City of Nedlands

Council Committee Meeting

7 December 2021

9.1	Consideration of Responsible Authority Report for 14 Multiple Dwellings, 7 Holiday Accommodation (Short Stay) and Café at 99 Broadway, Nedlands.....	55
10	Urgent Business Approved By the Presiding Member or By Decision	56
11	Confidential Items	56
	Declaration of Closure	56

U-Turn at Ground Floor Blind Aisle

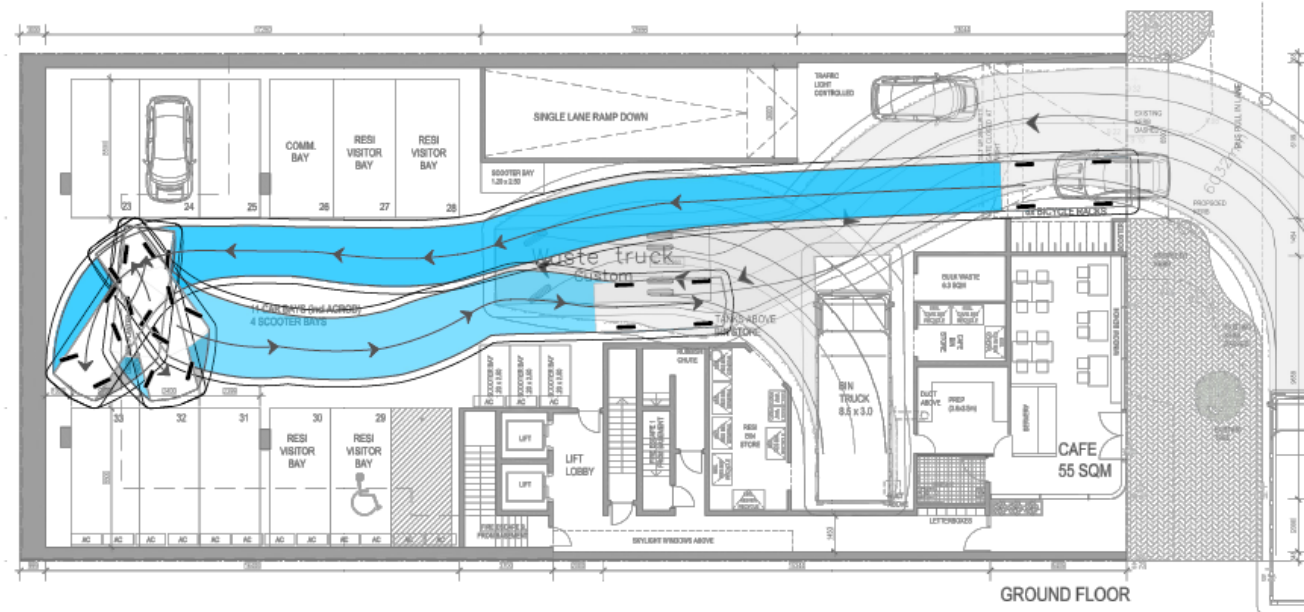
<p>4. Is the commercial bay as shown on GF plan (bay 26) compliant?</p>	<p>The commercial bay is 2.5m x 5.4m in dimension which is compliant for a User Class 2 facility.</p>
<p>5. It is anticipated that a car entering from Broadway into the ground floor, will look for a parking bay at the ground floor, if no space is available, the driver will search for parking elsewhere. Demonstrate with swept paths that a B99 vehicle can enter the ground floor and take a U turn at the end of the blind aisle.</p>	<p>According to AS2890.1, a maximum of 6 90-degree bays can be provided in public car parks without a turnaround bay since vehicles entering would be able to have visibility to if any parking spaces are available. The implementation of Green/Red indicator lights above each visitor parking bay could be considered.</p> <p>A swept path showing a B99 design vehicle undertaken a U-Turn is included below.</p>

Location of Stop/Give Way Lines at Basement Floor

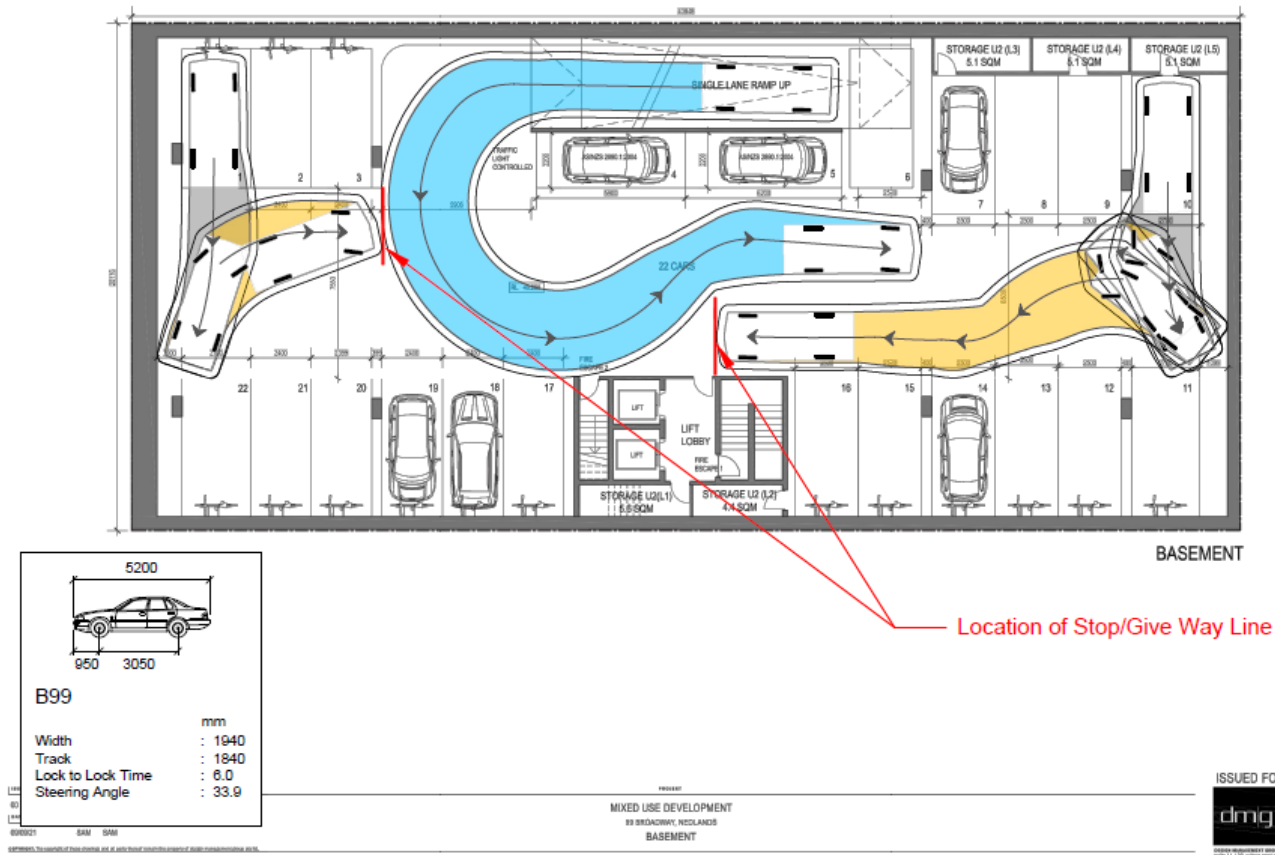
6. Show the locations of Stop/Give Way lines for Traffic light-controlled ramp at Basement and Ground floor, and demonstrate swept paths that the stopped vehicle(s) at the light will not obstruct vehicles entering to and

Skip Lift - Swept Path (Egress)

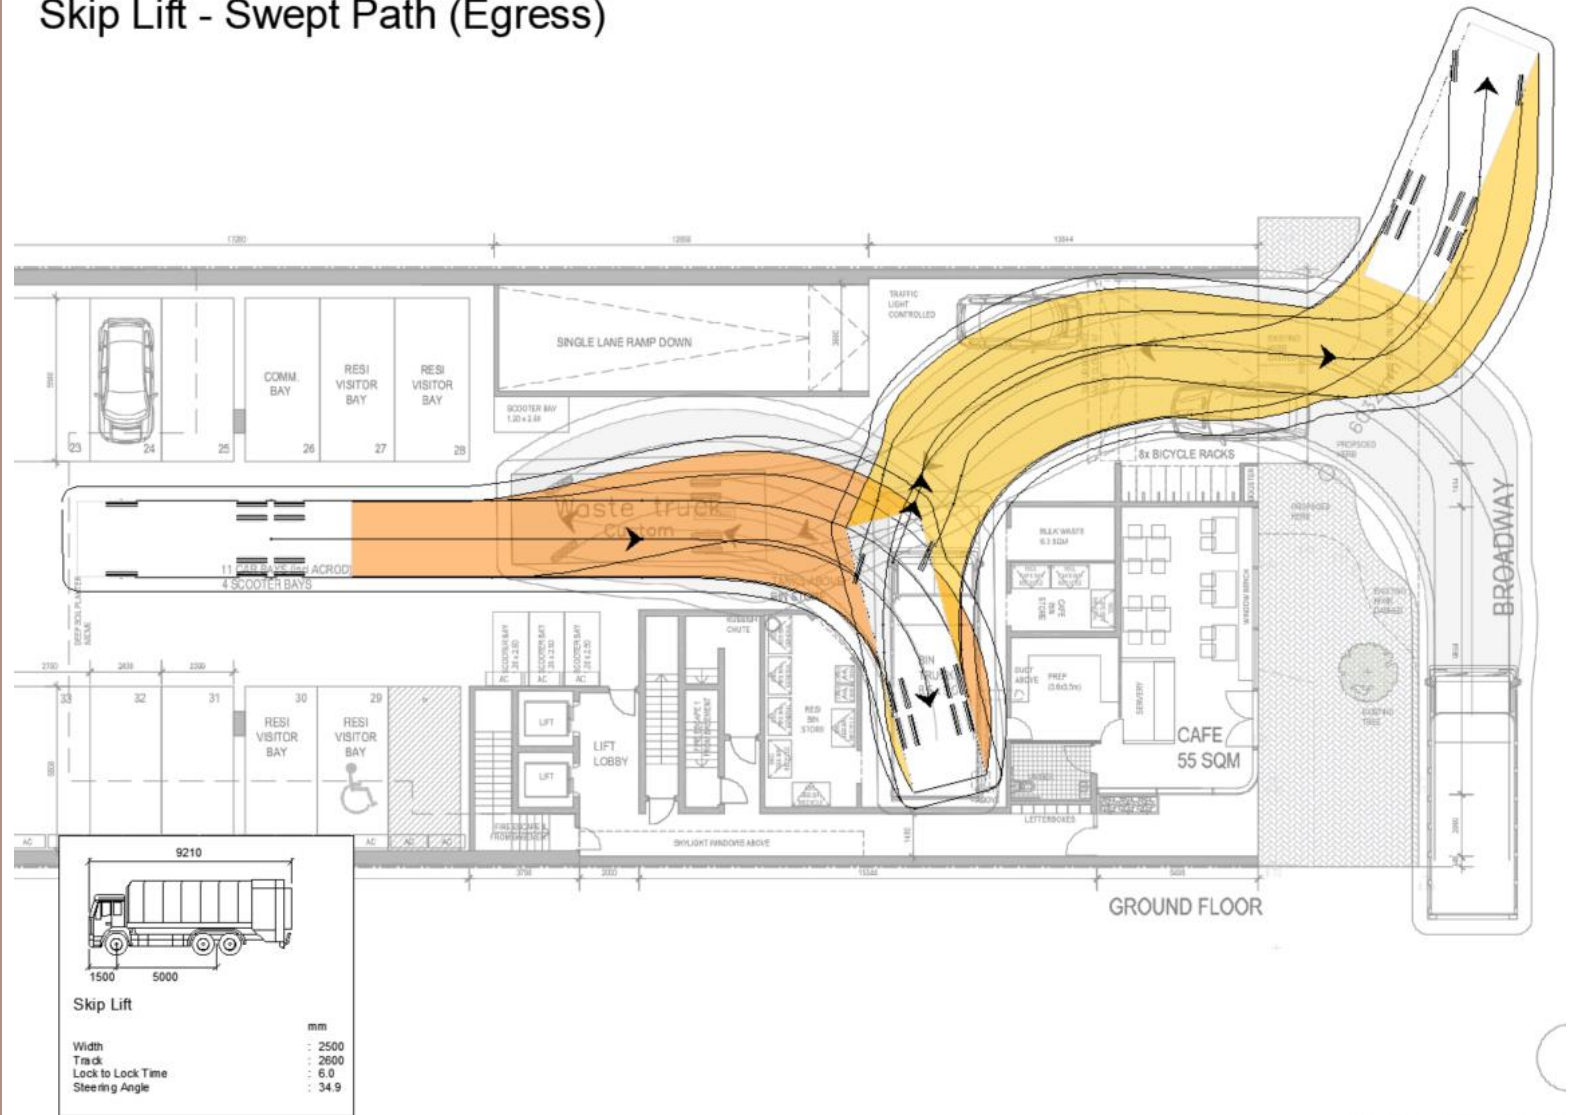
7. The design waste truck is 7.5m long, it will need another minimum 2.0m clearance for waste collection. So, a total of 9.5 m long bay is required for a 7.5 waste truck. During the waste collection process, two-way movements will
